Technical Letter  
No. 1110-3-511

31 May 2014

EXPIRES 31 MAY 2019  
Engineering and Design  
ARMY AIRFIELD/HELIPORT  
PLANNING AND DESIGN CHANGES

Appendix A  
Army changes to UFC 3-260-01

#### 4-7 ELEVATED HELIPADS

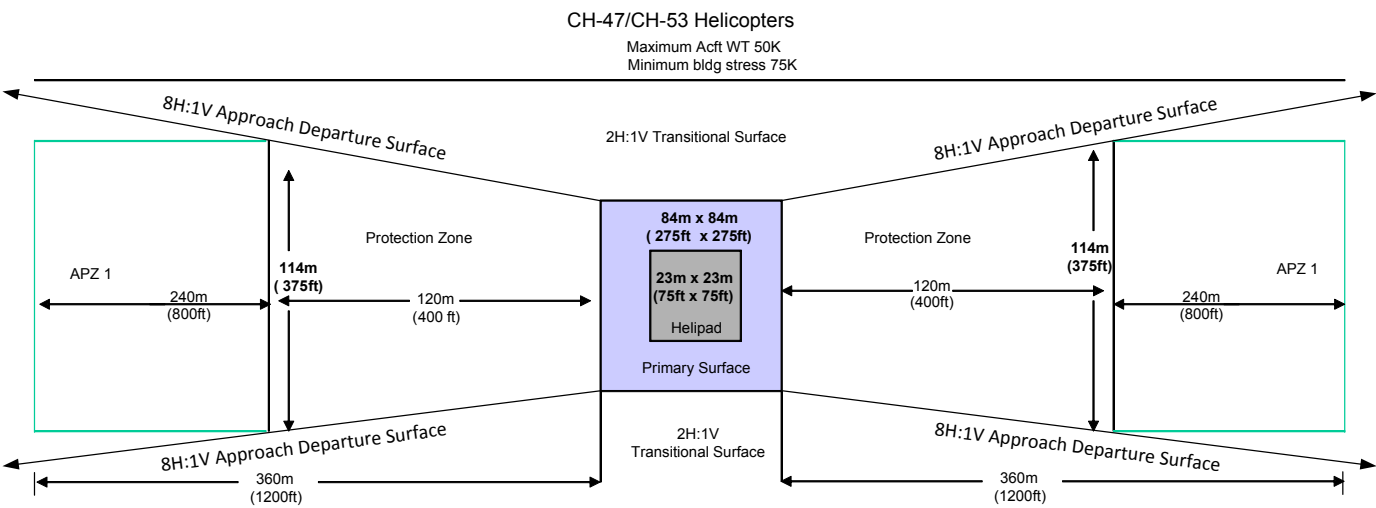
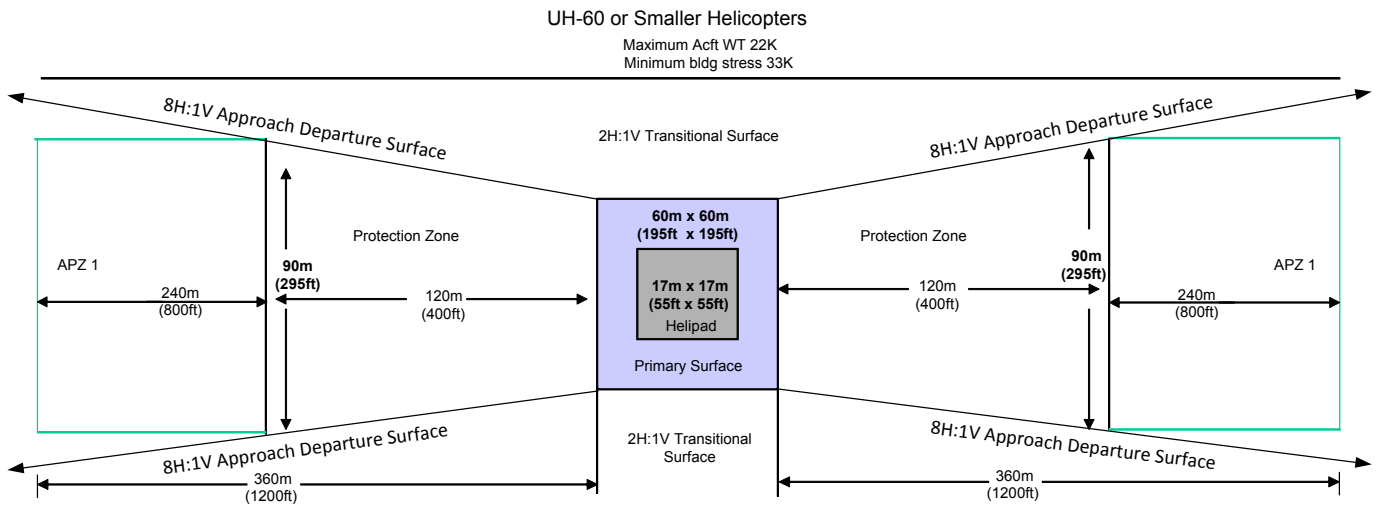
A-28. Page 86, Para 4.7: Add the following as Paragraph 4.7 and renumber the remaining paragraphs (originally Para 4-7 thru 4-13) accordingly:

4-7.1 **General.** Elevating helipads 6 feet (1.8 m) or more above the level of the roof will generally minimize the turbulent effect of air flowing over the roof edge. While elevating the platform helps reduce or eliminate the air turbulence effects, a safety net may be required. Helipads should be constructed of metal or concrete. Surfaces should have a broomed pavement or other roughened finish that provides a skid-resistant surface for helicopters and non-slippery footing for people. The primary surface should be contained on the structure.

4-7.2 **Rooftop and Other Elevated Helipads.** Elevated helipads and any supporting helipad structure should be capable of supporting the dynamic loads of the design helicopter (stressed to 1.5 times the weight of the design helicopter).

### Elevated Helipad Layout Criteria

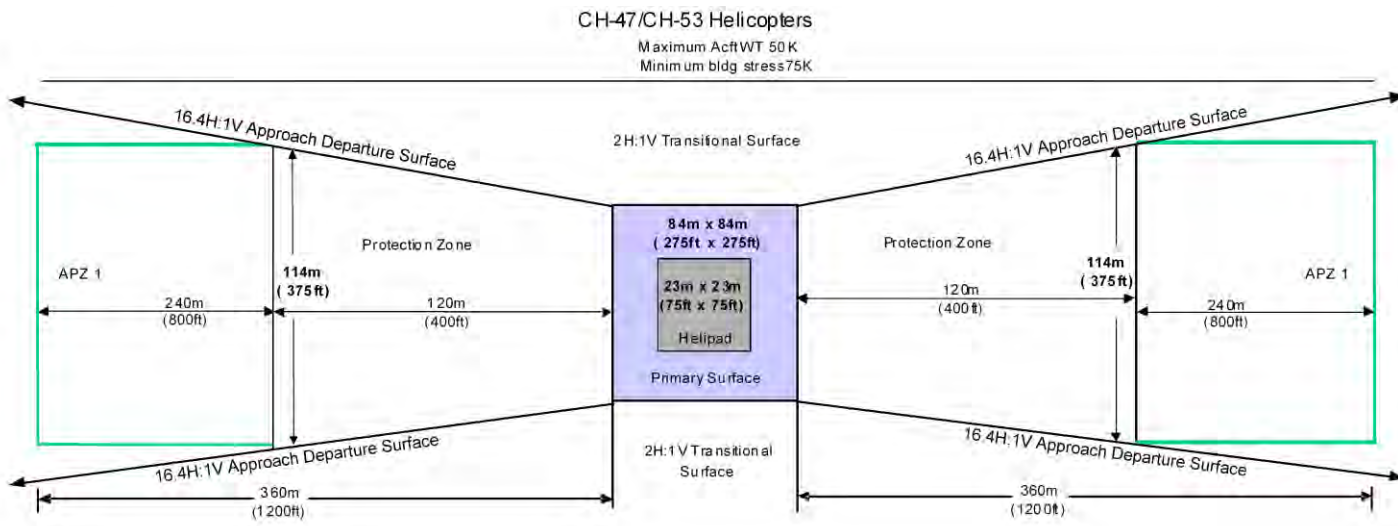
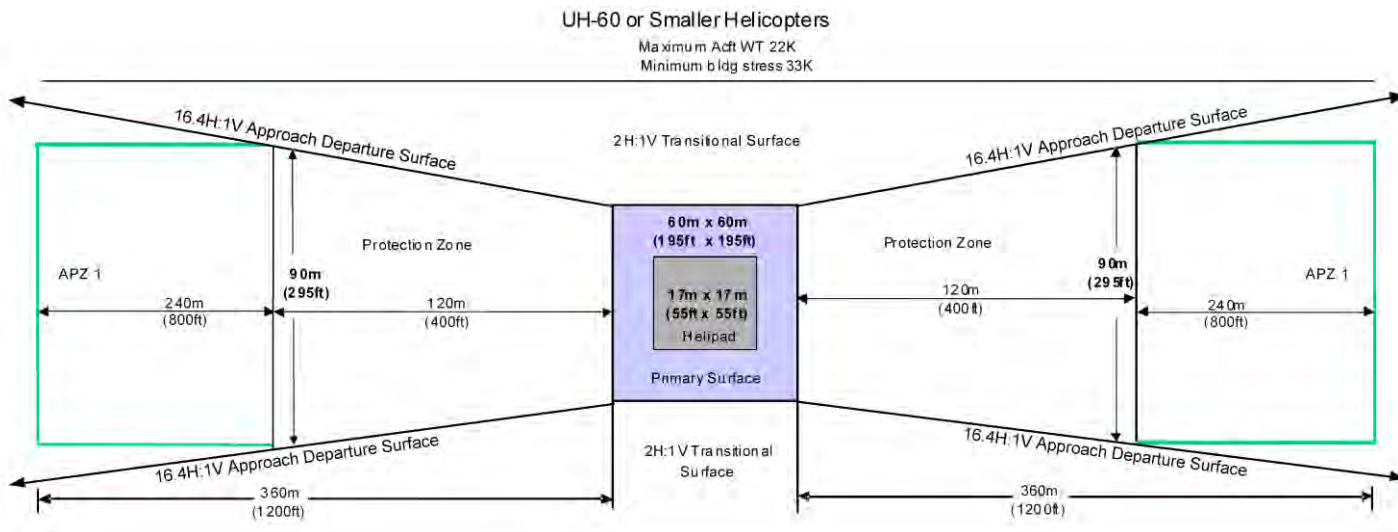
4-7.4 **Layout.** Add the following layout diagrams to Chapter 4 for Elevated Helipads:
